OLD BEGA HOSPITAL
ARTS & CULTURAL CENTRE

DESIGN DEVELOPMENT
29.03.2018

REVIEW OF FEEDBACK ITEMS

CAFE

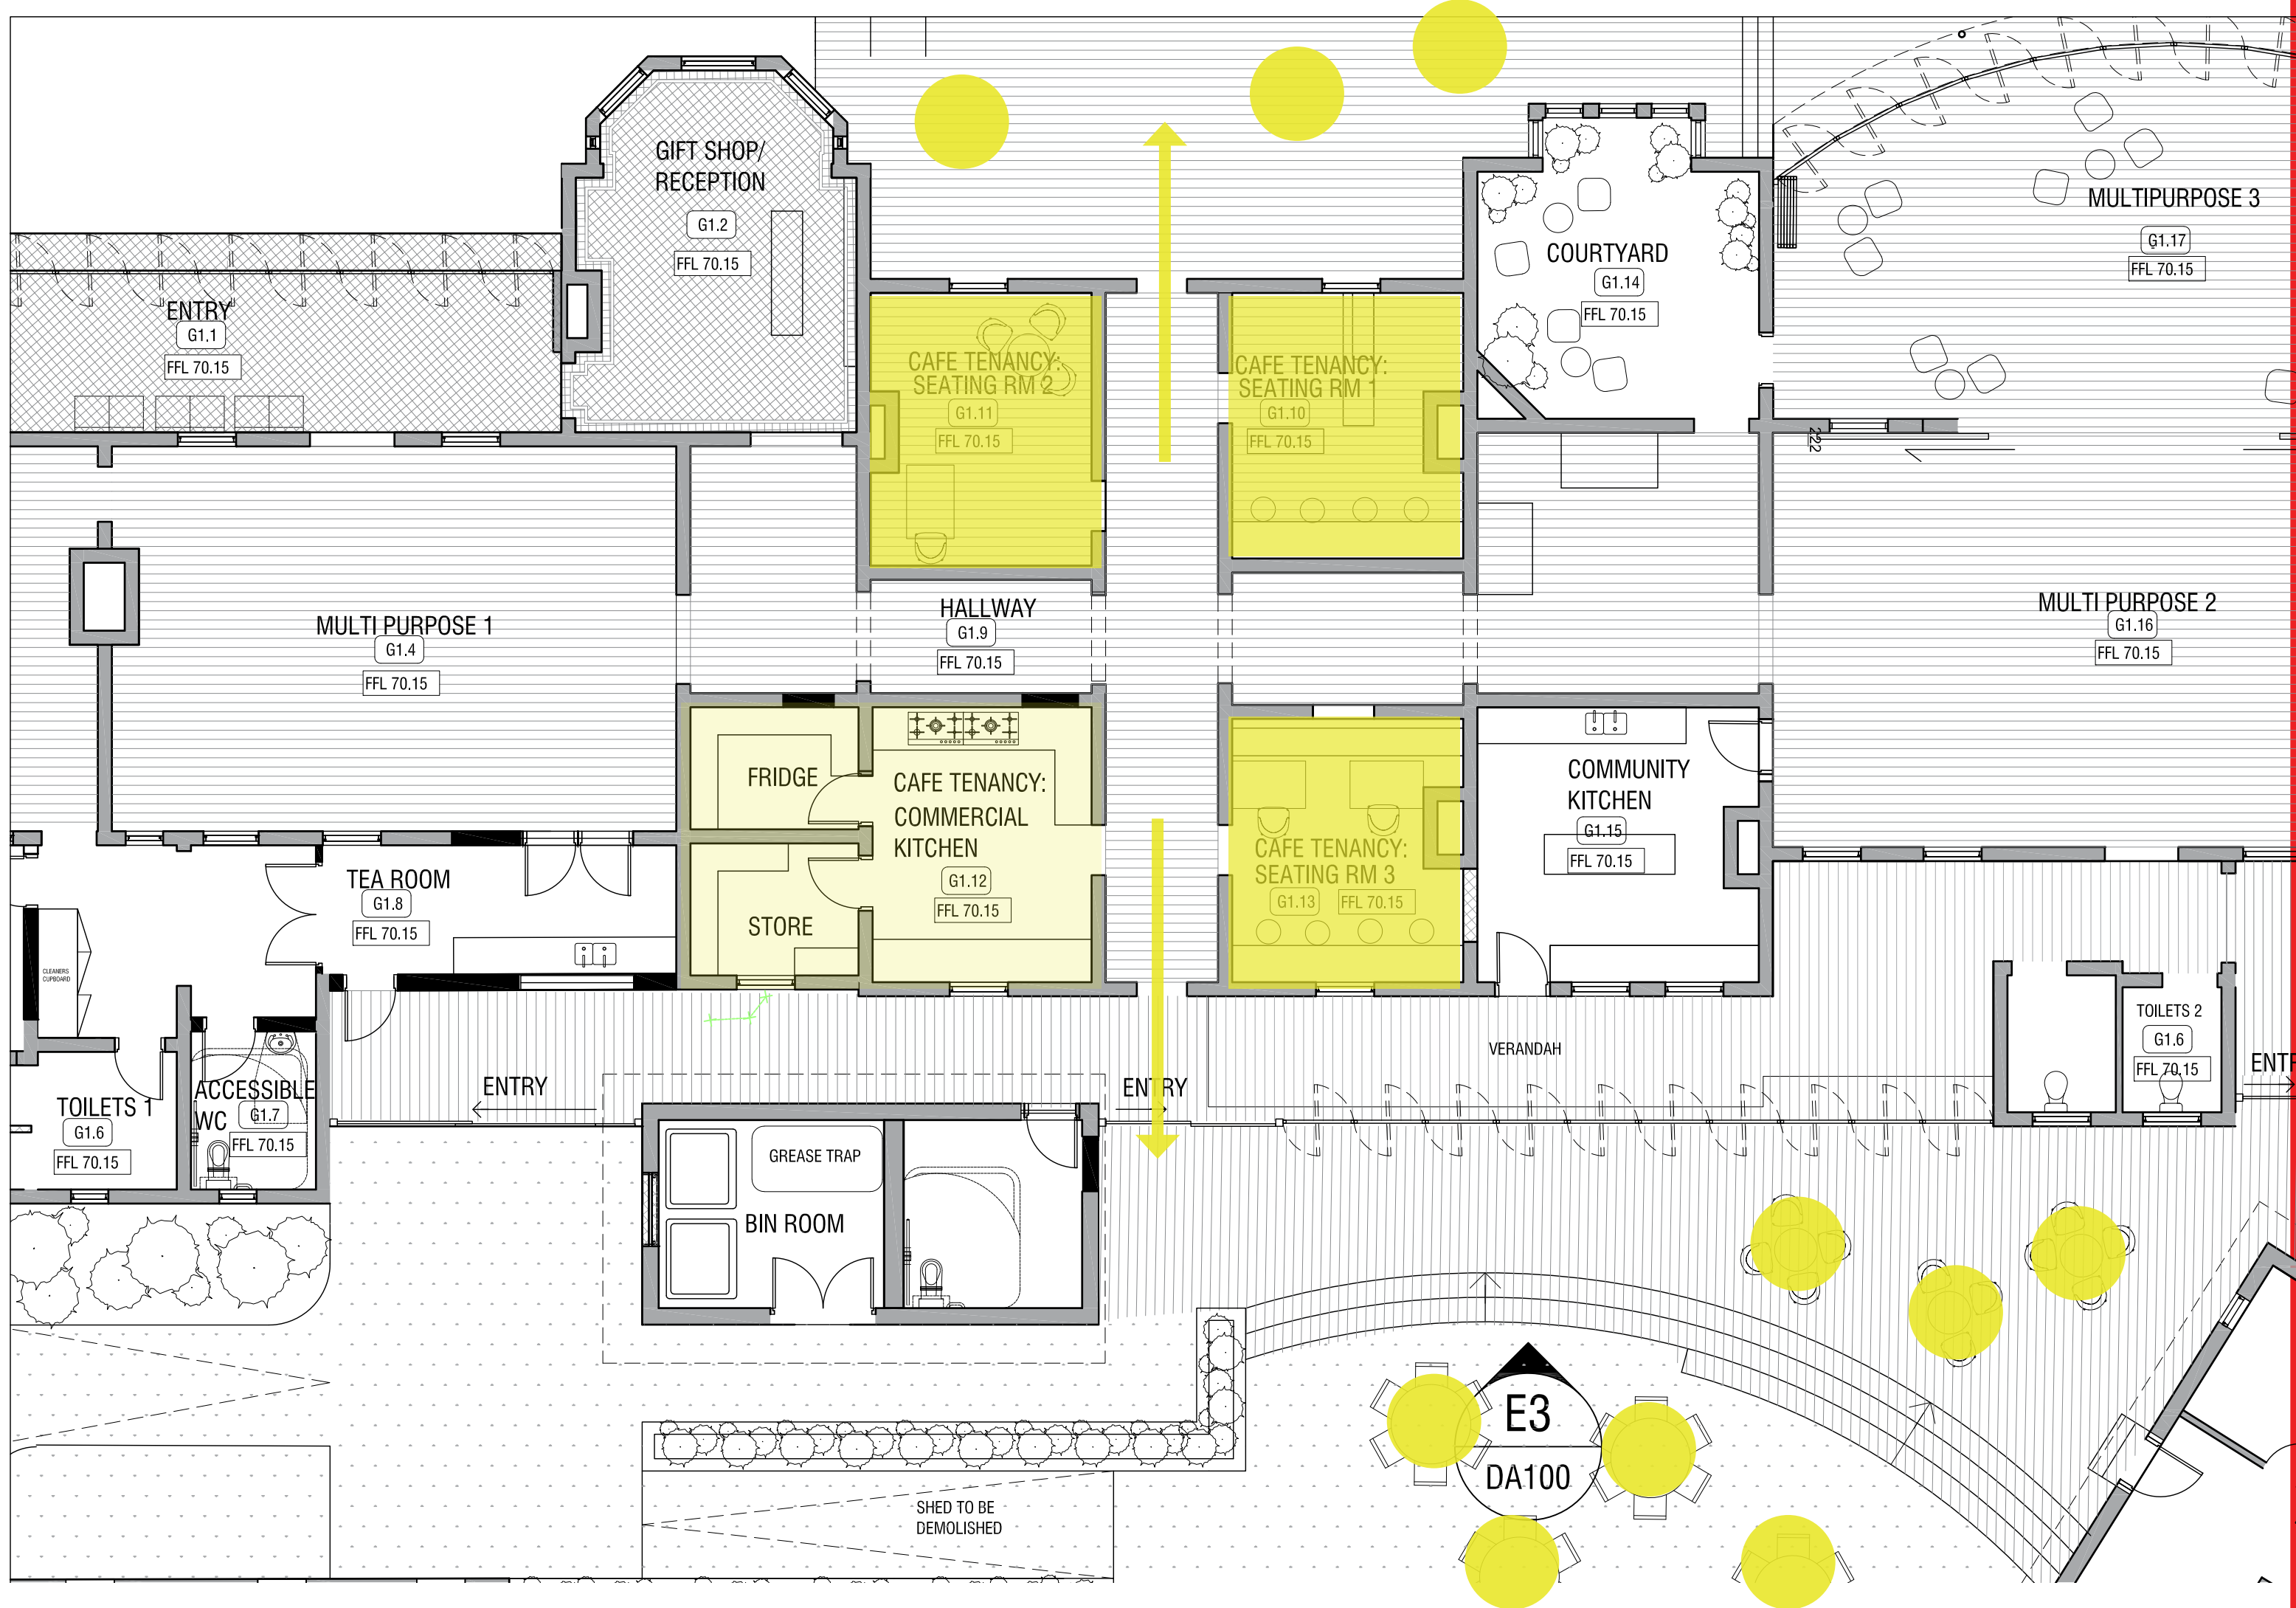
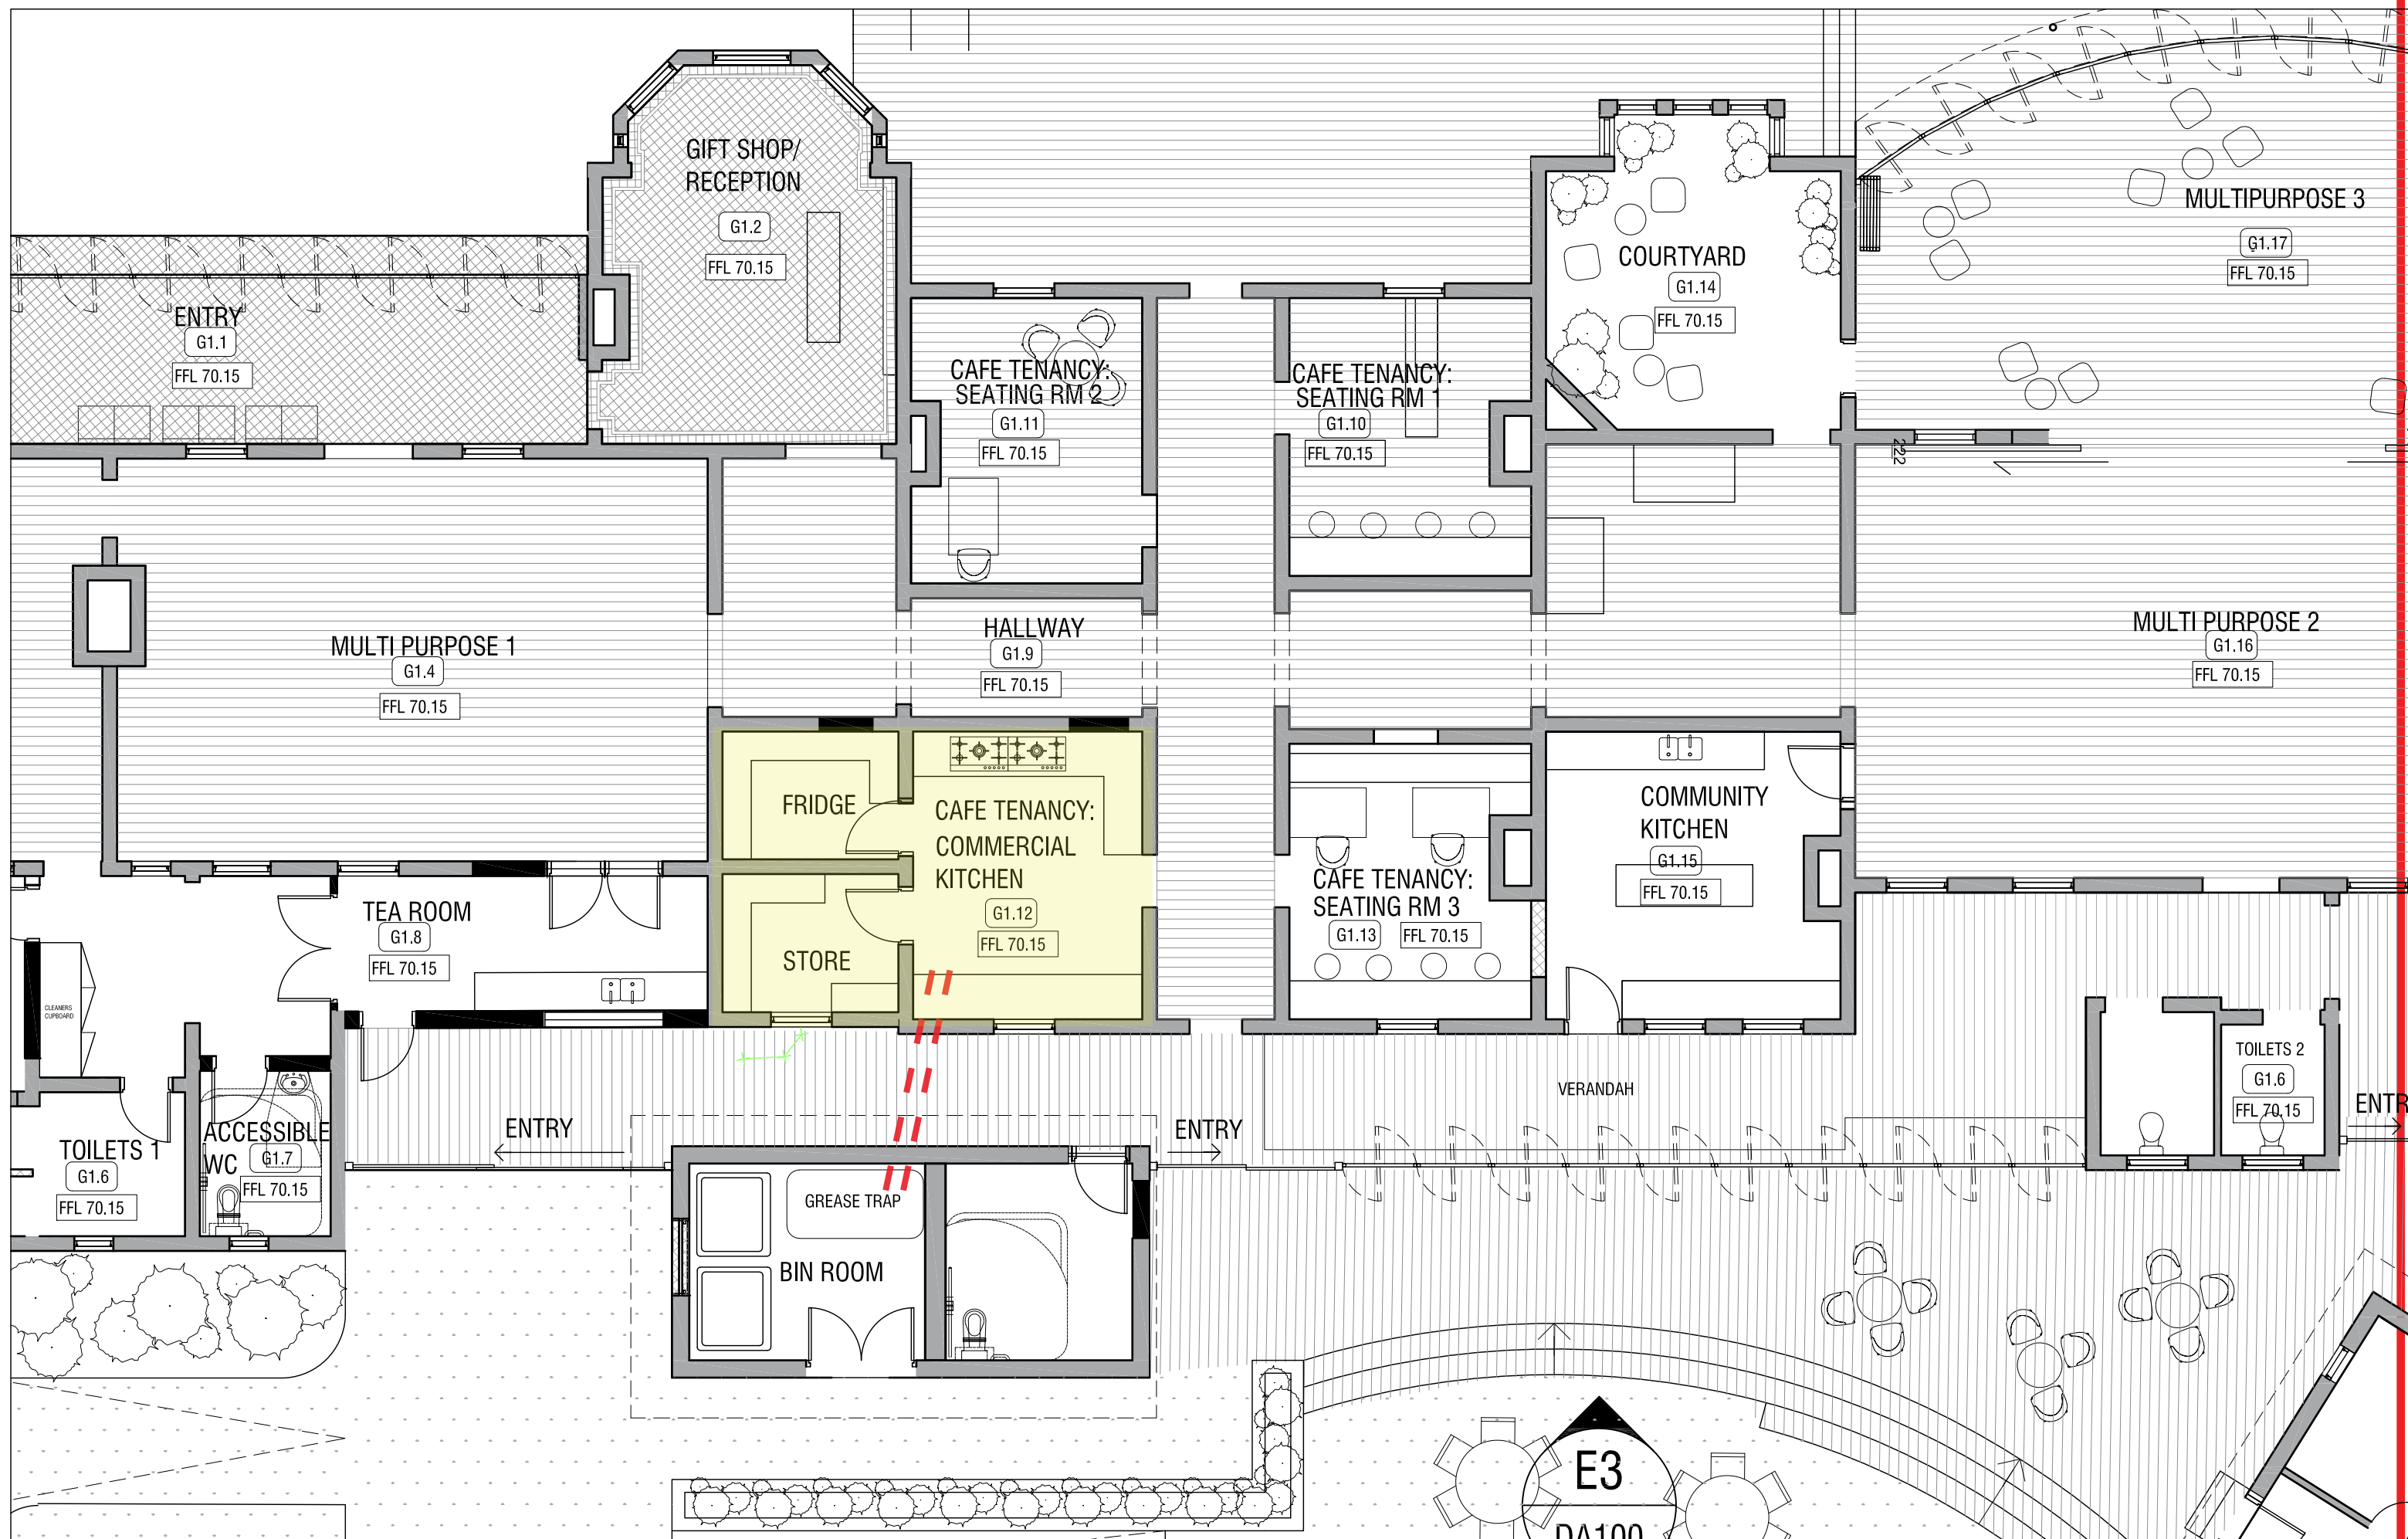
7. CAFE SEEMS TO HAVE TOO MANY ROOMS, WHILE THERE ARE NOT MANY SMALL HIRE OR LEASE SPACES. PRESUME THAT IS JUST A MATTER OF FITTING OUT - IF CAFE OPERATOR DOESN'T WANT TO USE A ROOM, THEN IT IS AVAILABLE FOR HIRE/LEASE.
8. TOO MANY/TOO FEW TOILETS, E.G. COMPARED WITH LOCAL SHOPPING MALL. THINK THERE MAY BE MORE TOILETS IN THE MALL THEN FIRST APPEARS. AND MALL HAS MAINLY SHORT TERM VISITORS, WHILE OBH MAY HAVE PEOPLE THERE FOR SEVERAL HOURS. AND THE BCA WILL DETERMINE WHAT IS REQUIRED.
9. WHERE DOES THE GREASE TRAP GO FOR THE CAFE? CAN IT BE OUT OF THE WAY OF THE CORRIDOR BETWEEN THE MORGUE AND THE MAIN BUILDING? WHERE DO BINS GO FOR THE CAFE? COULD BOTH GREASE TRAP AND BINS GO INTO THE STORAGE SPACE IDENTIFIED IN THE MORGUE.

WOULD NEED TO WIDEN DOORS

GREASE TRAP LOCATION
